# CANON SERVICE MANUAL

## Canon FTb

## Canon New FT-b Release Lever Change

## Canon FTb Service Parts Change( Mirror Replacement)

## 9. Miscellaneous Parts

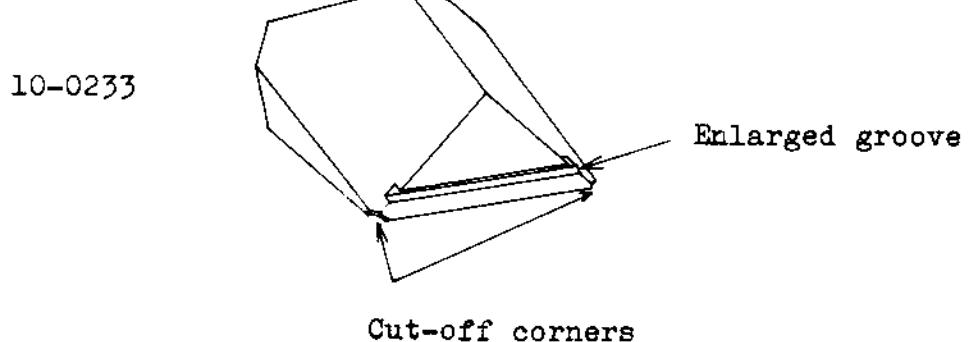
13-1530	Mask (pg. 3)	13-1549	Accessory Shoe (pg. 2)
13-1535	Light Shield (pg. 5)	96-0021	Coupling Gear*(pg. 3)
13-1536	Light Shield (pg. 5)

\* Correct misprint "Caupling" → Coupling also.

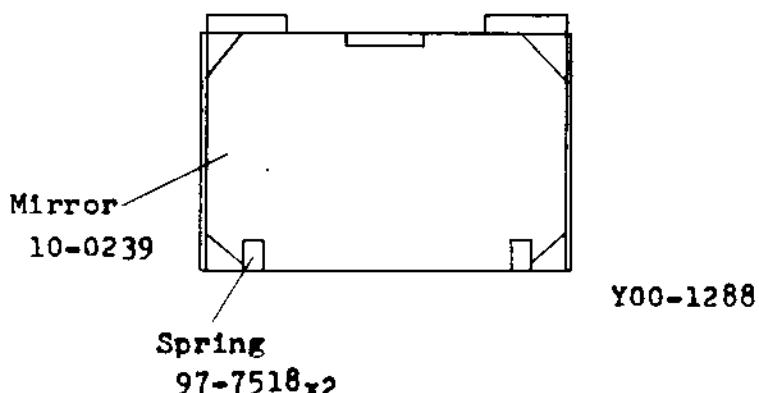
Mirror(10-0239) and Spring(97-7518) have been added to the Service Parts list so the mirror can be changed without removing the mirror box as is necessary when changing the mirror unit.

To change the mirror without removing the mirror box use the following procedure.

1. Apply a small amount of solvent (ME Ketone) to the two springs and remove them.
2. Put solvent between the mirror and the mirror base and remove the mirror.
3. Clean the mirror base with solvent.

Note: Do not remove the protective tape from the mirror until finished.

1. Apply Plyobond to the mirror base as shown in the drawing.
2. Carefully slip the mirror under the spring at the back of the base.
3. Apply Diabond to the Springs (97-7518) x 2 and push the springs in place.

## Canon FTb Maximum Aperture Correction Lever Unit Change

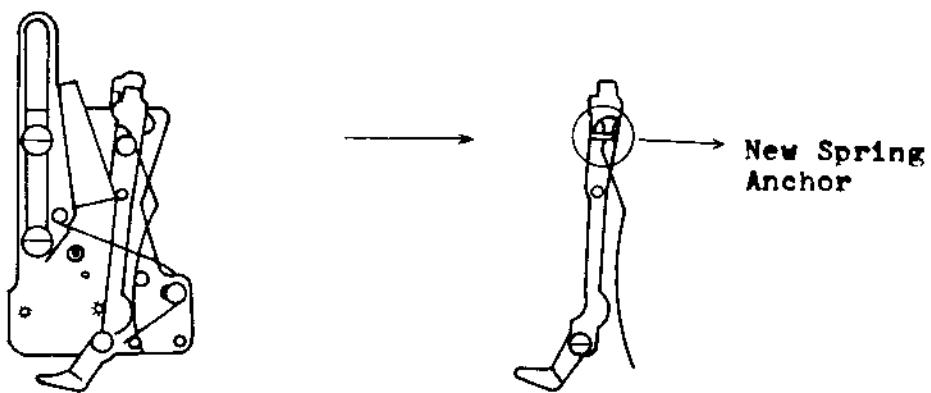
Due to results of severe vibration test, it has been found that the spring shown in the drawing can come off of the dowel. Therefore the end of the spring is now held in a hole rather than around the dowel.

## Canon FTb Self Timer Change

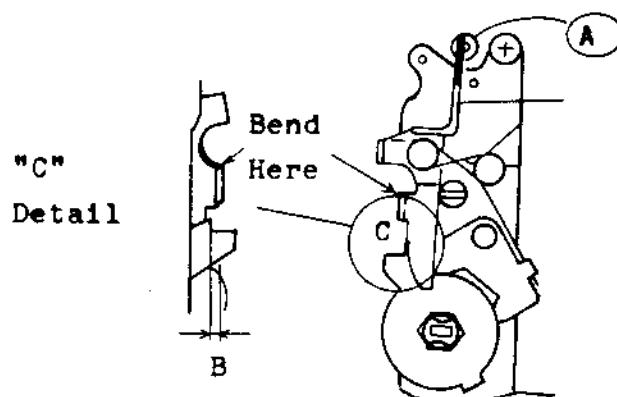
Old self timers can normally be adjusted to work by bending the tab shown toward the main body of the self timer. (This reduces the "B" dimension shown in the partial drawing.)

It is not recommended to bend the top of the lever "A" since this normally produces a temporary fix only.
